REVISION 1
TO
51S-1 SERVICE BULLETIN NO 2

51S-1 COMMUNICATIONS RECEIVER (522-2245-030)
51S-1A COMMUNICATIONS RECEIVER (522-2546-030)
51S-1AF COMMUNICATIONS RECEIVER (522-3156-001)
51S-1B COMMUNICATIONS RECEIVER (522-3857-001)
51S-1F COMMUNICATIONS RECEIVER (522-2498-001)

SERVICE BULLETIN NO-2

SUBJECT: Replacement of transformers T14 and T15 with mechanical filter

51S-1 HF Receiver, Partial Schematic Diagram
Figure 1

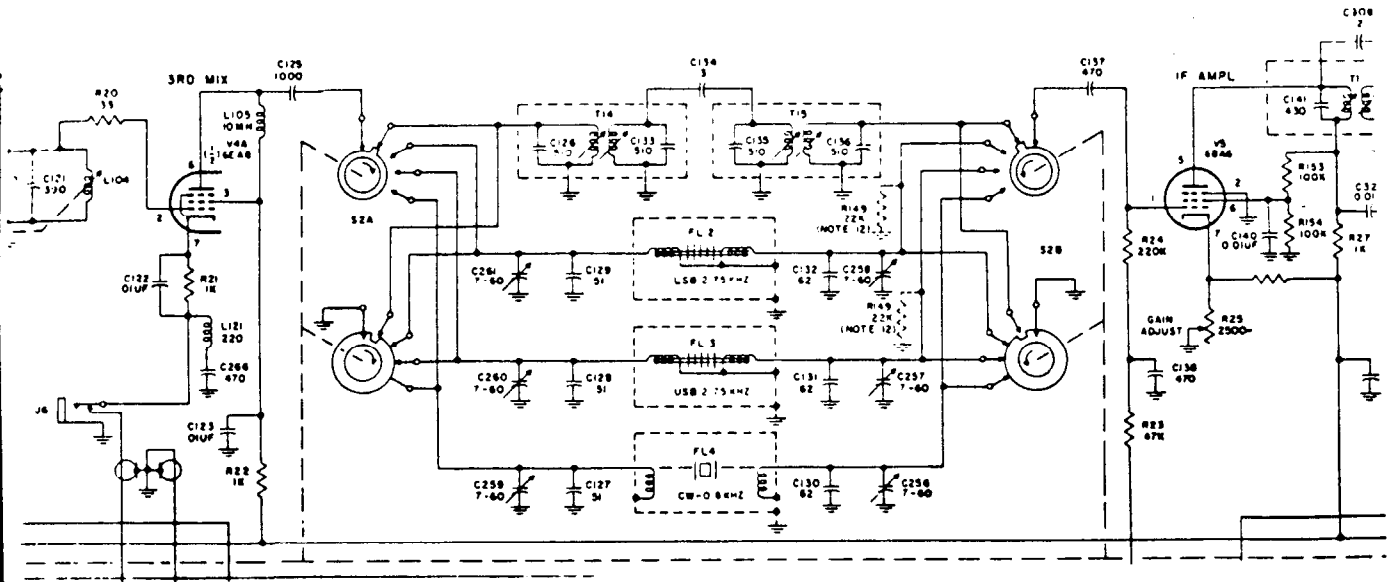
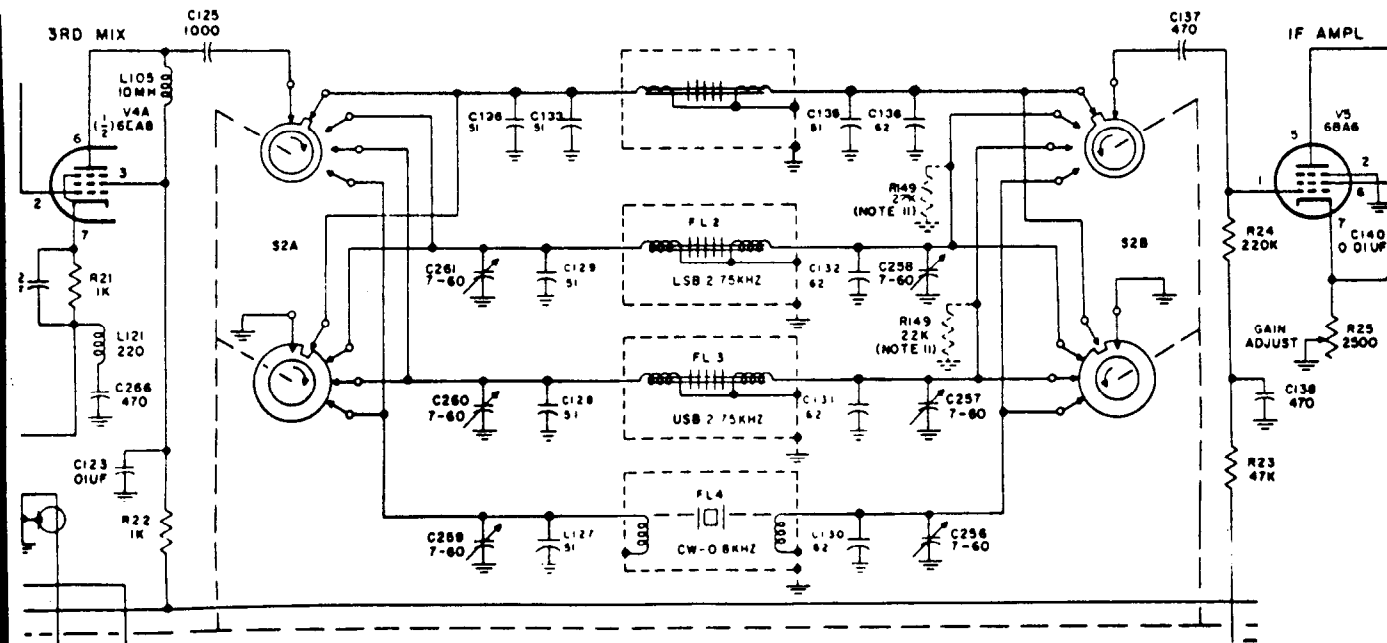
7. Page 3, modification information chart (Collins part number 280-3779-010), has been added to the list of parts.
8. Page 4, figure 1, partial schematic diagrams showing production configuration A before and after the modification has been added.

NOTE: The modification procedures depend upon the circuit configuration of the receiver. Configuration A in figure 1 shows fixed resonating capacitors (C127 through C132) across the input and output of each filter. Configuration B in figure 2 is the same circuit except C127 through C132 are removed and resonating capacitors C127 and C130 are switched to the input and output of the selected filter.

- b. Disconnect from S2B, the wire which was at T15. For configuration A, connect wire (421-2220-000) and parallel 51 pF (912-3858-000) and 62 pF (912-3864-000) capacitors to S2B as shown in figure 1.

- c. Disconnect from S2A, the wire which was at T14. For configuration-A, connect wire (421-2220-000) and parallel 51 pF (912-3858-000) capacitors to S2A as shown in figure 1.

Figure 2

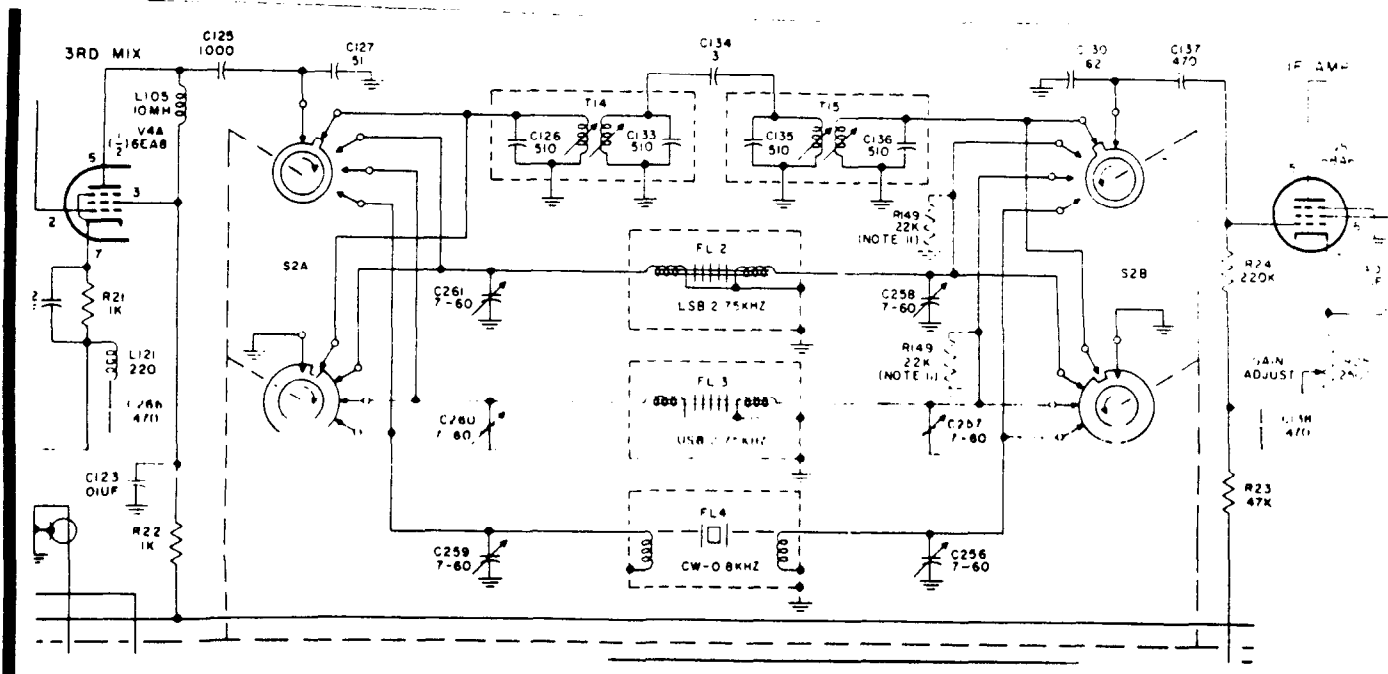
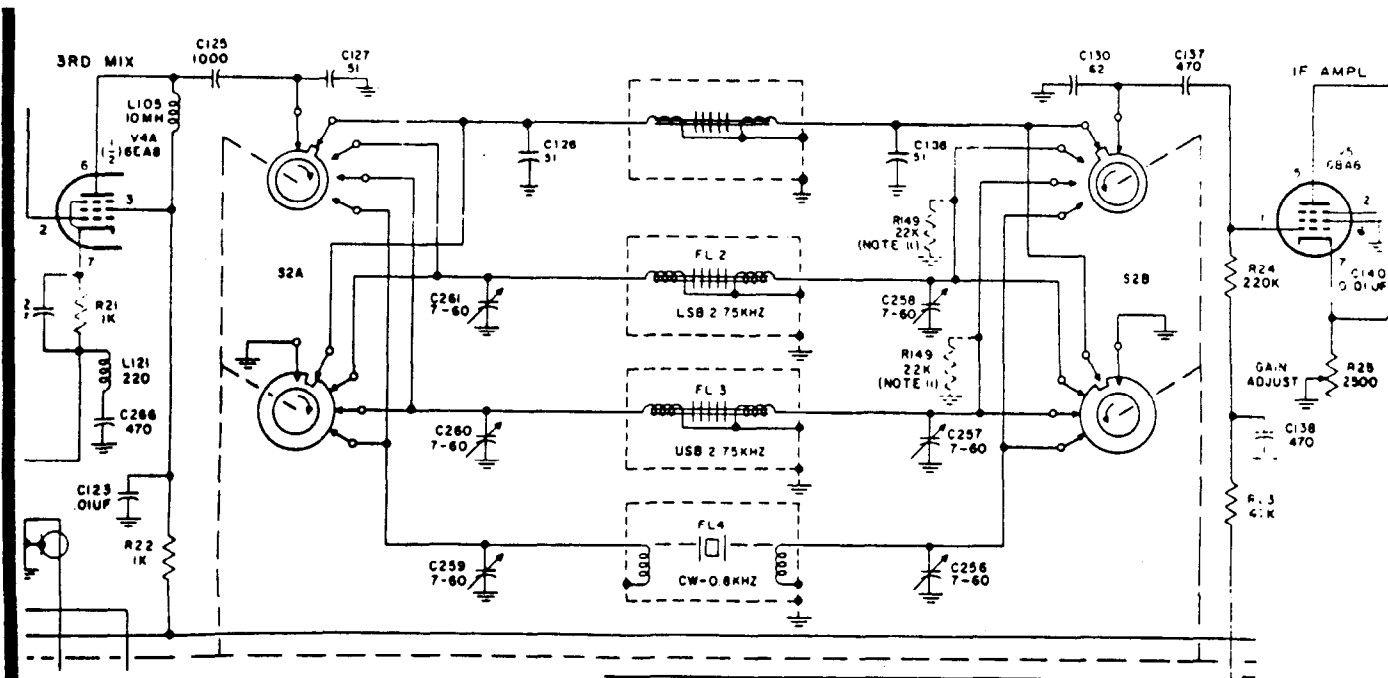
9. Page 5, figure 2, partial schematic diagrams showing production configuration B before and after the modification has been added.

For configuration B, connect wire (421-2220-000) and 51 pF (912-3858-000) capacitor to S2B as shown in figure 2.

For configuration B, connect wire (421-2220-000) and 51 pF (912-3858-000) capacitors to S2A as shown in figure 2.

51S-1 HF Receiver, Modification Components Locations
Figure 3

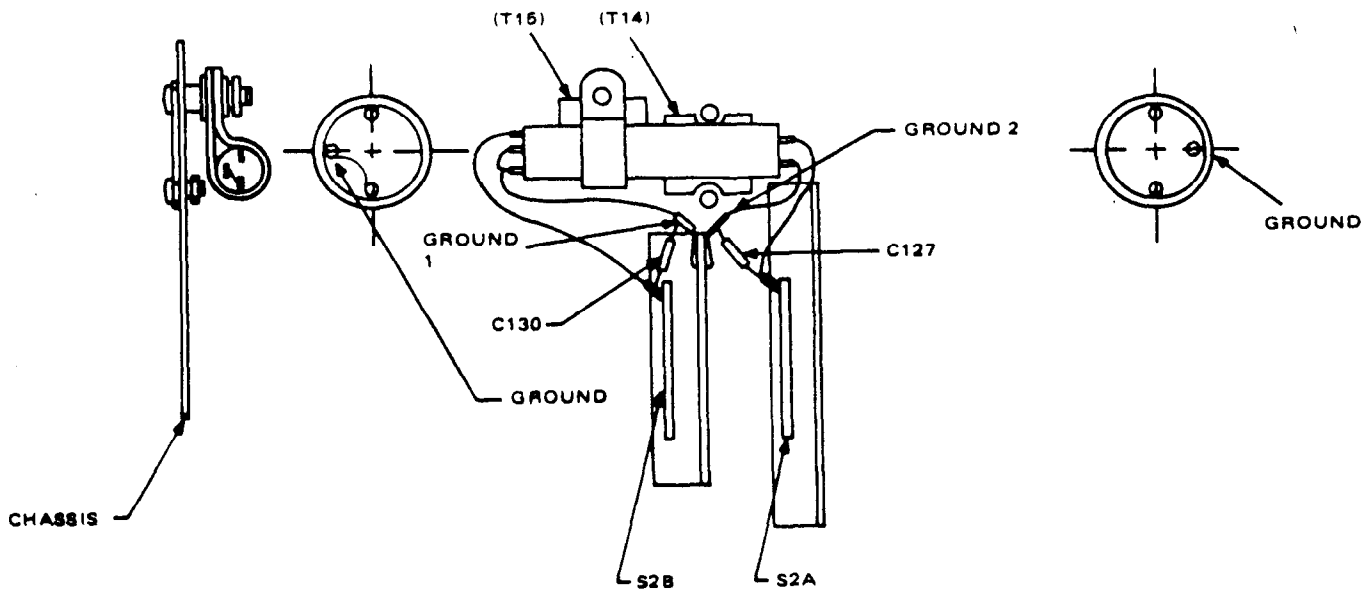
- d. Remove the bus wire from GRD1 that was connected to T14 and T15. Connect wire (422-2220-000) and loose end of capacitor in step b. to GRD 1. Insulate wire with sleeve (152-1558-000). Refer to figure 3.
- e. Connect bus wire (422-2220-000) and loose end of capacitor in step c. to GRD 2 (figure 3).
- f. Install plate covers (549-2836-002) on top of chassis; leave the screw hole to which the nylon filter clamp will be installed (step i.).
- g. Install wires from S2A and GRD 2 to mechanical filter (526-9378-000). Refer to figure 3.
- h. Install wires from S2B and GRD 2 to mechanical filter.
- i. Place nylon clamp over the mechanical filter and secure clamp to chassis hole (step f.).
